Austin MG

January, 1974

INDUCTION MANIFOLD HEATER
AND THERMOSTAT

AUSTIN MARINA

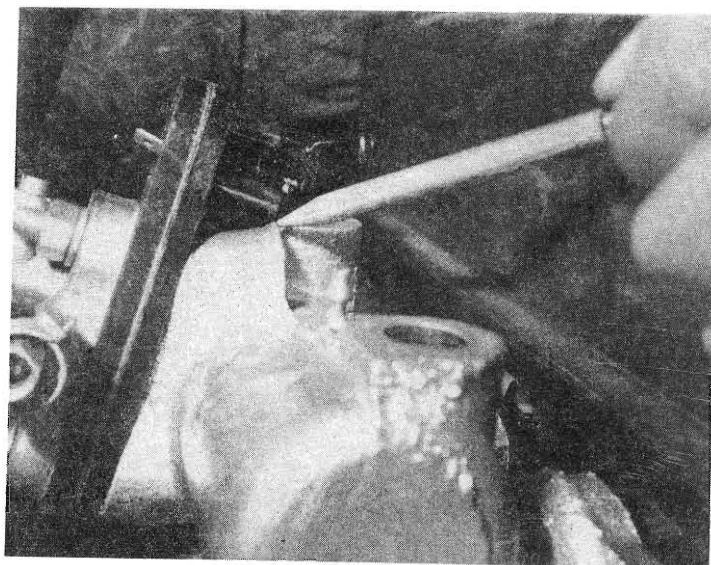
Should complaints be received of the accessory fuse blowing when the ignition is first switched on, and outside temperatures are at freezing or below, then it is possible that the induction heater thermostat switch is the cause.

Due to casting variations on the top of the induction manifold, a sharp lip is sometimes present in this area and, in some cases, touches the underside of the "Otter" switch, causing a short circuit. As the induction heater is only in circuit for a relatively short period of time, this problem can be difficult to diagnose; but it should be remembered that the switch only functions at low temperatures. Removal of the excess material on the top of the induction manifold with a file will prevent further difficulty.
